ADDENDUM # 2

PROJECT: Fore River Short Stay Hospital, Portland, Maine

PROJECT NO: 05-4898

DATE: December 6, 2006

Drawing No.
SKA-7
Revision To:
A1.00A, A1.00B
Project No.
F05-4898
Drawn By
EWG

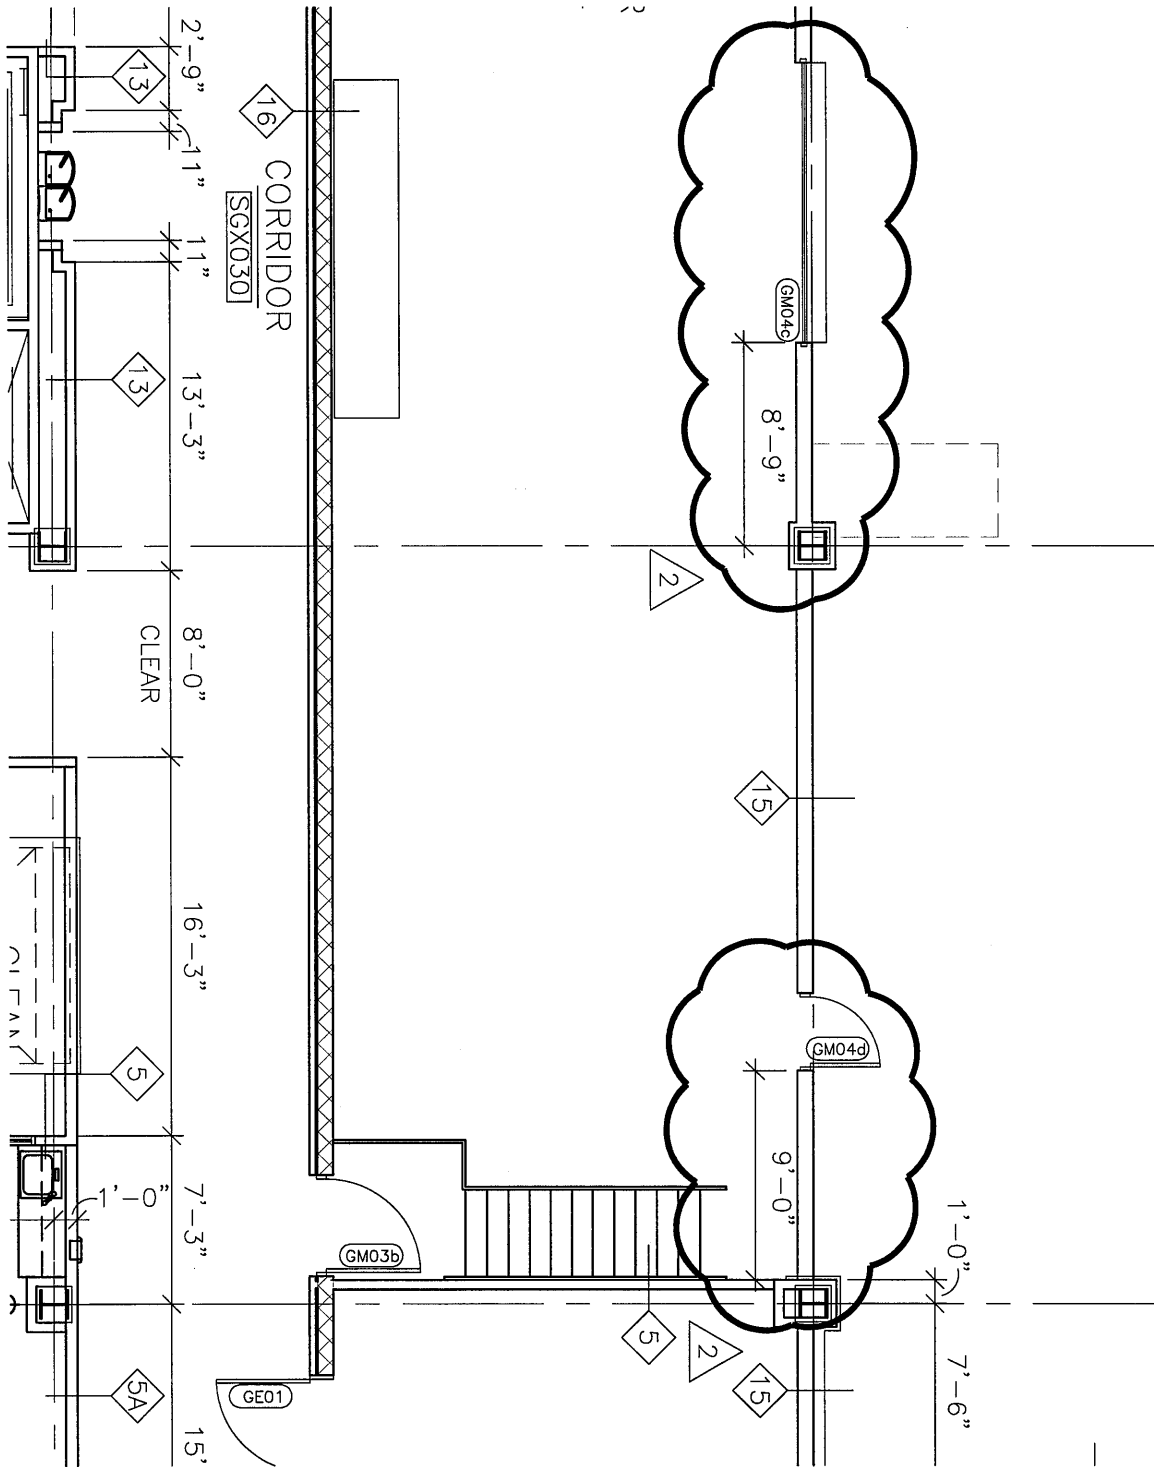
- 1. Added door GX045A
- 2. Revised door GX045
- 3. Revised Dimensions

Drawing No.
SKA-11
Revision To:
A1.01B
Project No.
F05-4898
Drawn By
EWG

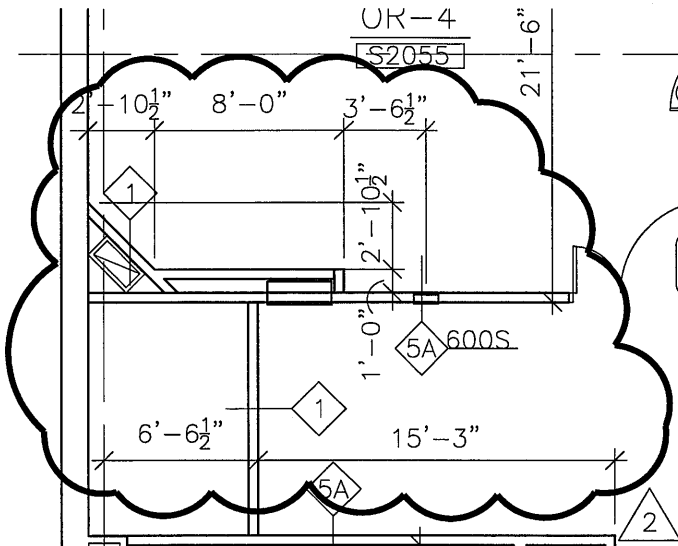
1. Addition of Detail Bubble 5/A1.29
2. Addition of elevation tag 26,27/A8.11

Drawing No.
 SKA-21

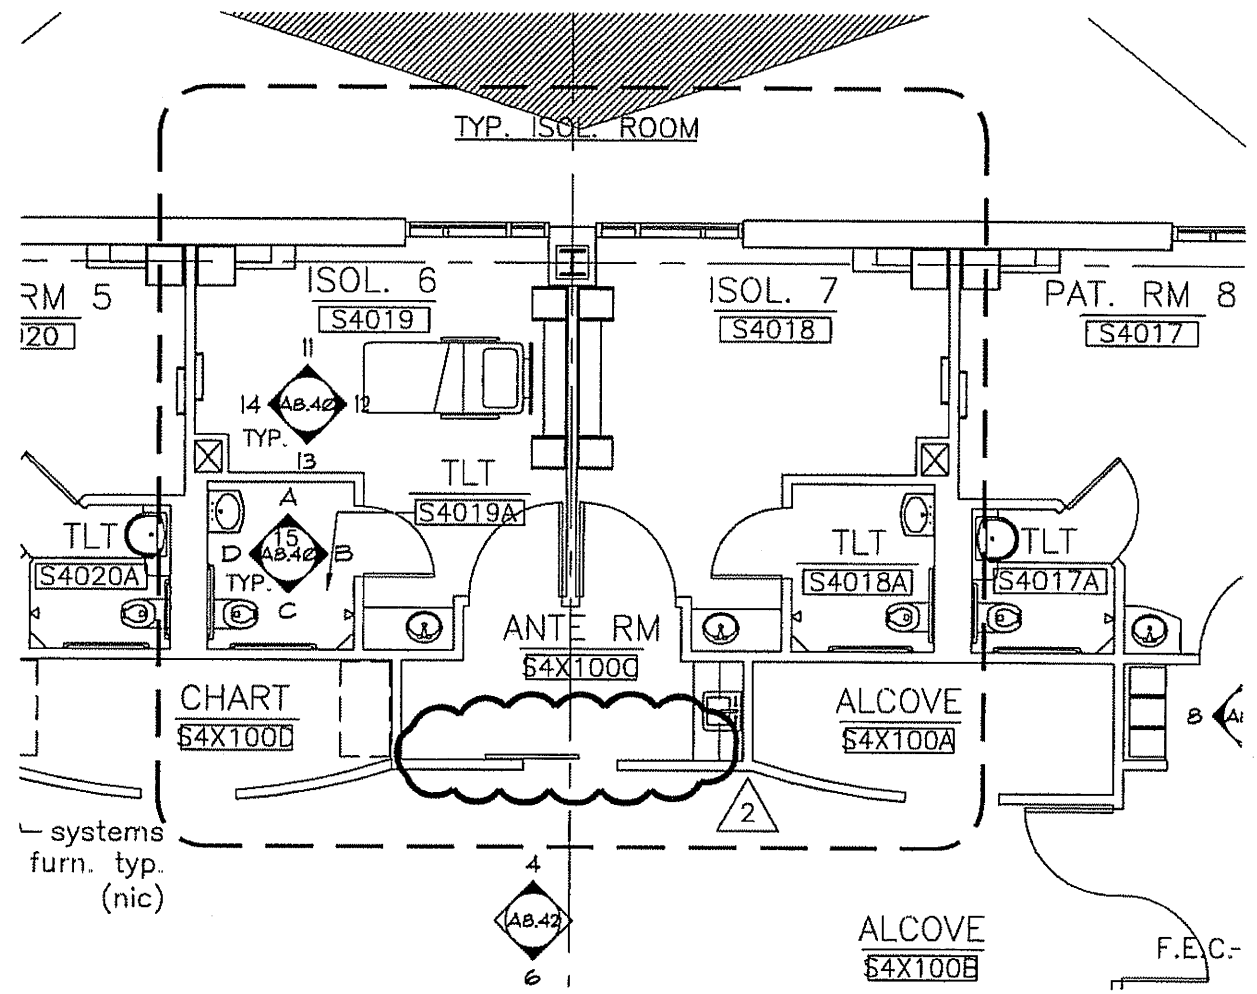
1. Add Ante Room Sliding Door

Revisions
 ADDENDUM #2
 Drawing No. SKA-22
 Revision To: A1.04B
 Date 12.06.06
 Scale AS NOTED
 Project No. F05-4898
 Drawn By ART

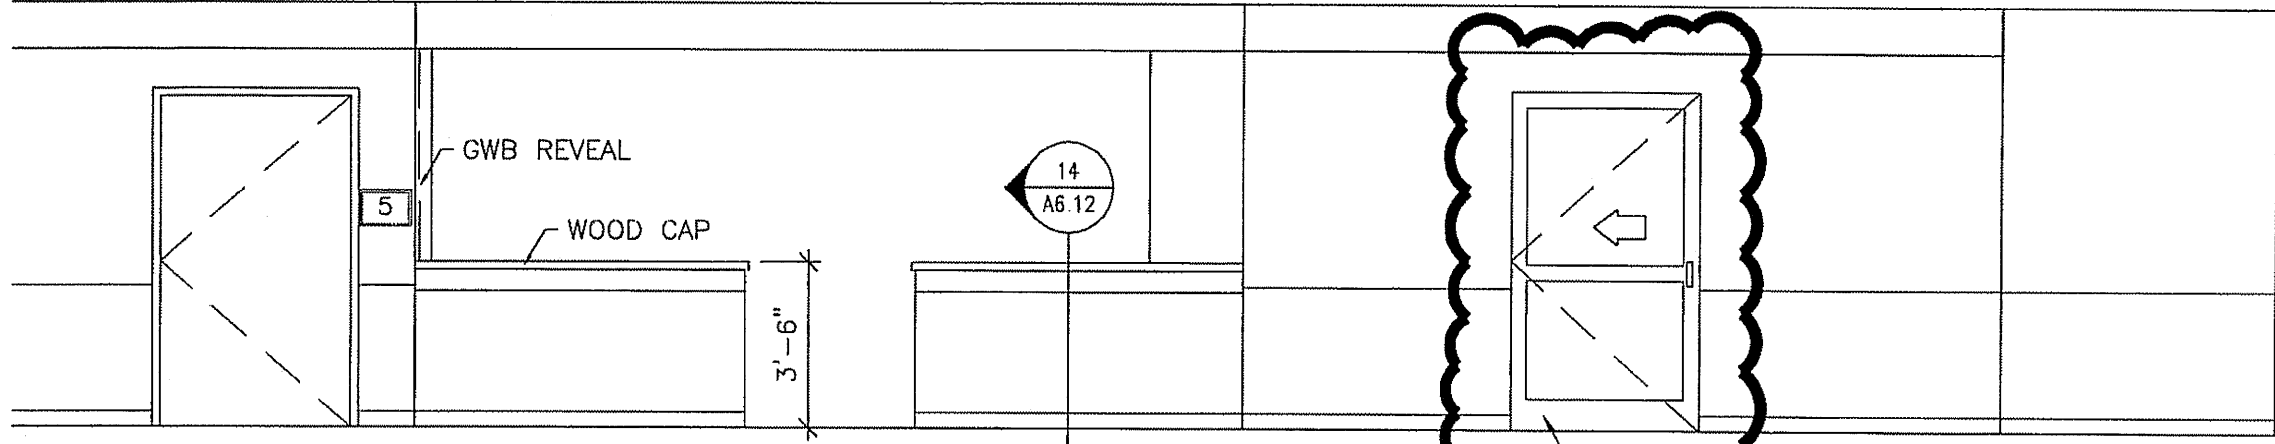
1. Add Ante Room Sliding Door

Revisions
 Δ ADDENDUM #2
 Drawing No. SKA-23
 Revision To: 4/A8.42
 Project No. F05-4898
 Date 12.06.06
 Scale AS NOTED
 Drawn By ART

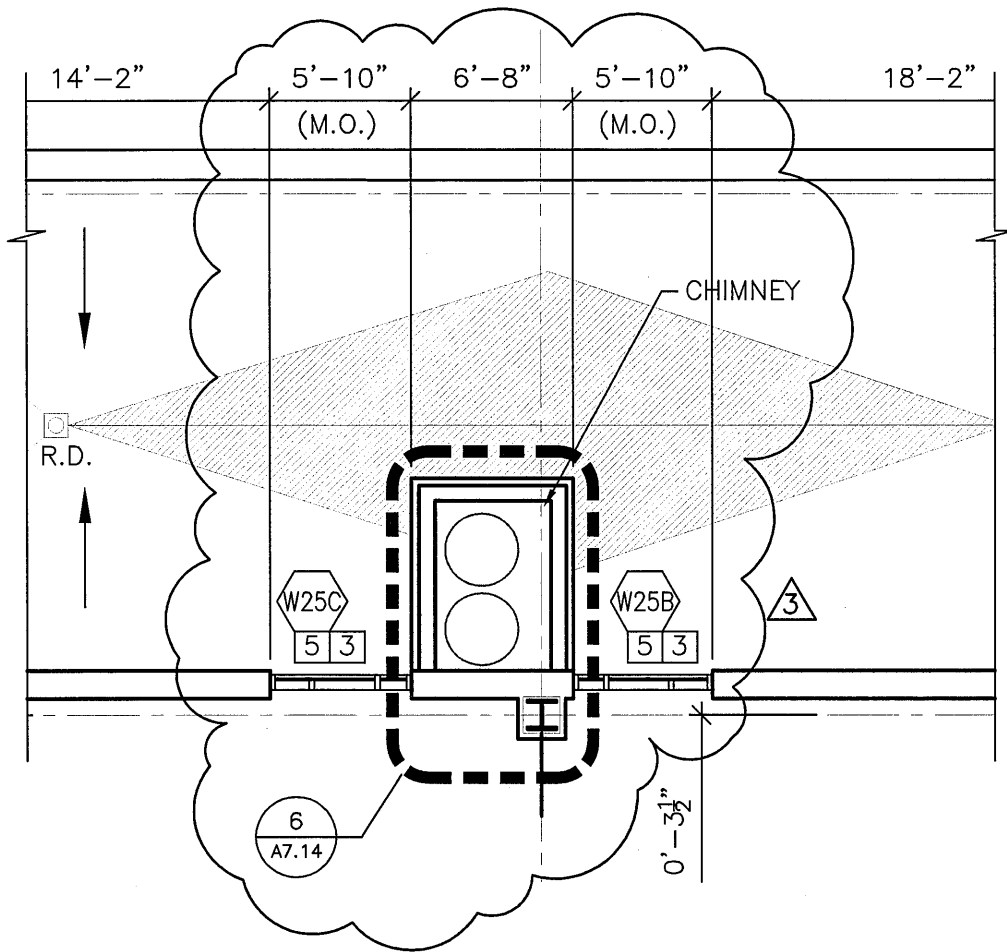
1. Add Ante Room Sliding Door

Drawing No.
SKA-26
Revision to :
A3.05
Project No.
F05-4898
Drawn By
JLL

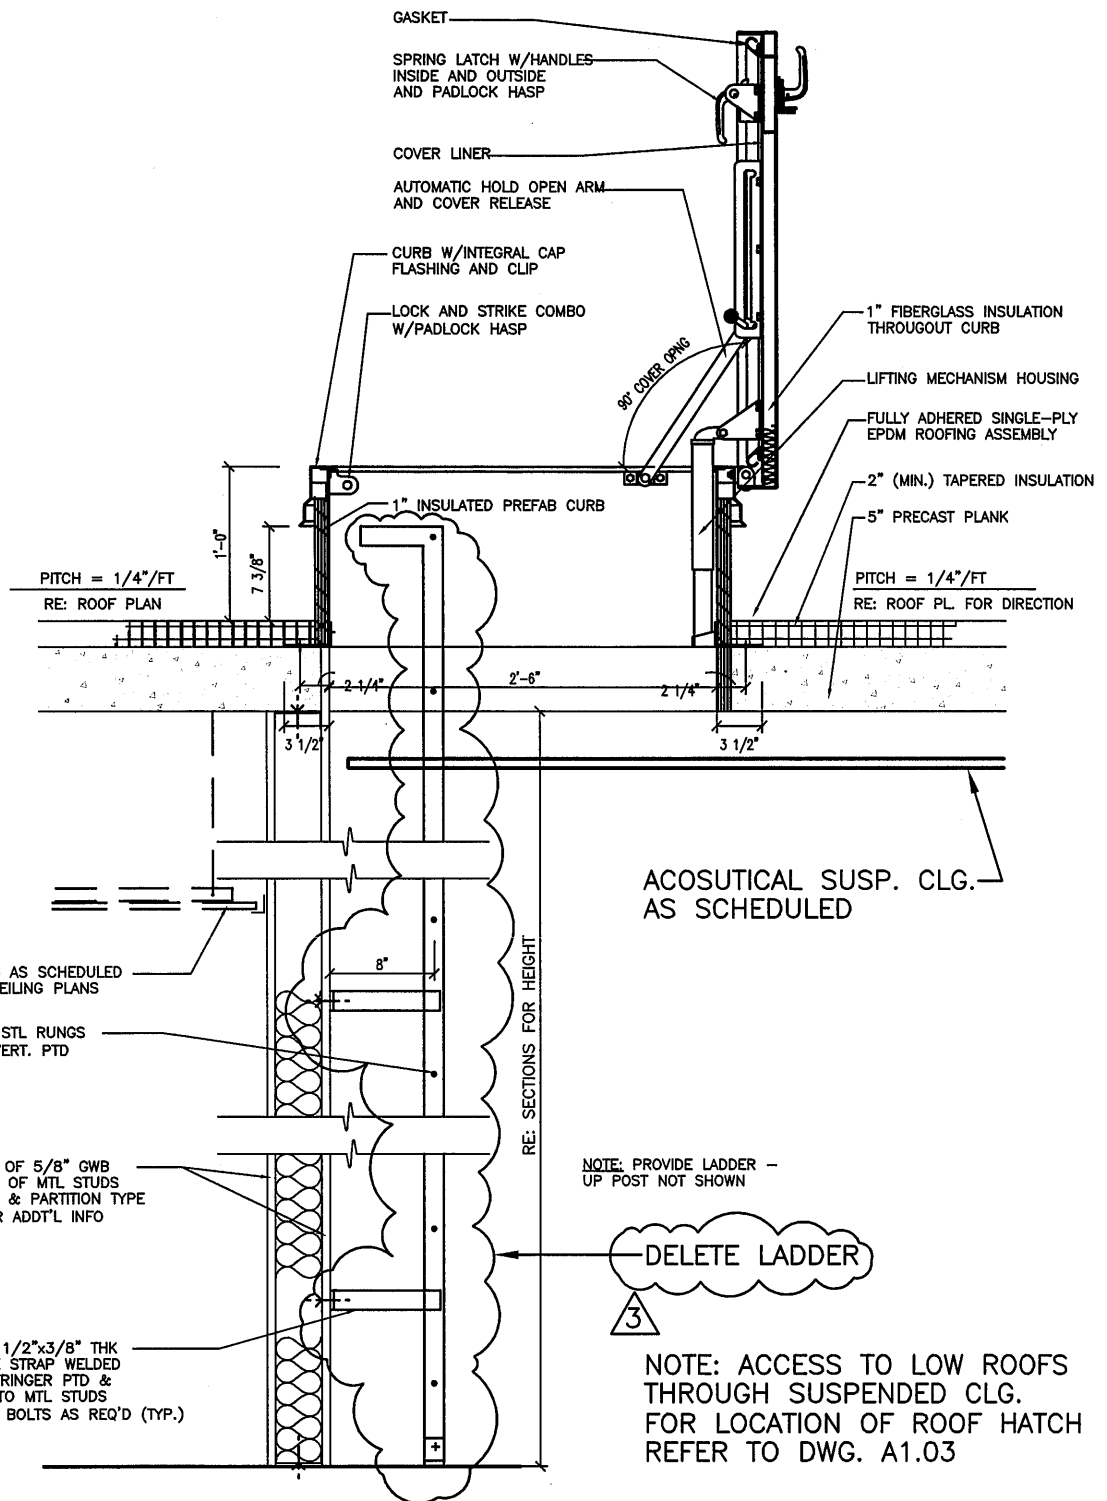
1. Detail Revision @ Foundation Wall

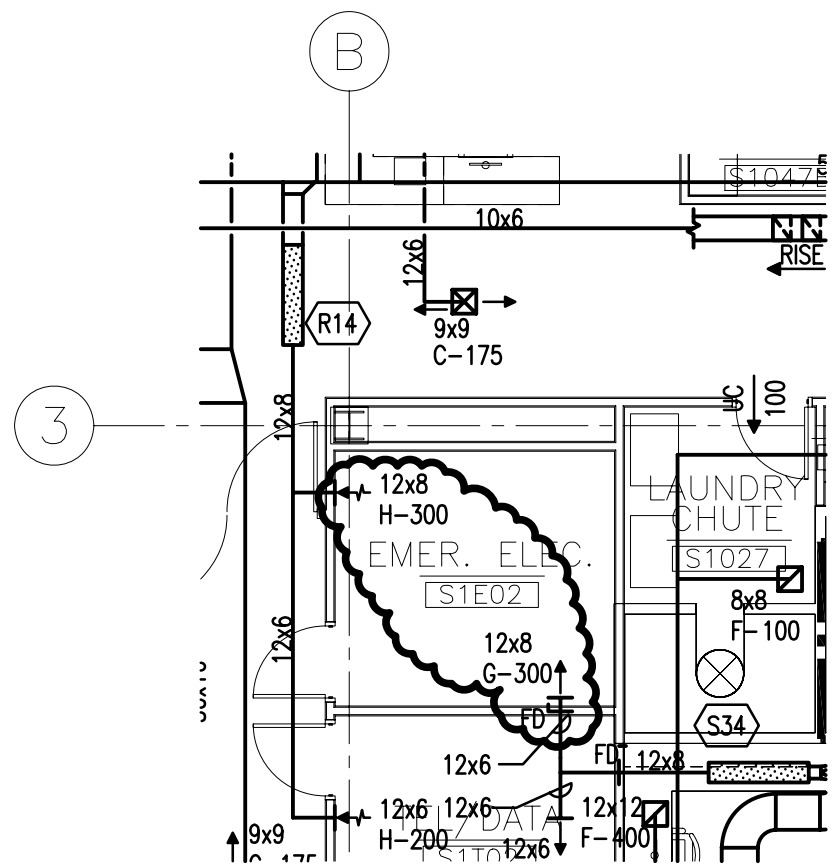
1. Revisions made to CFM's & GPM's on Box Schedule.
2. Revised thermostat control wiring.
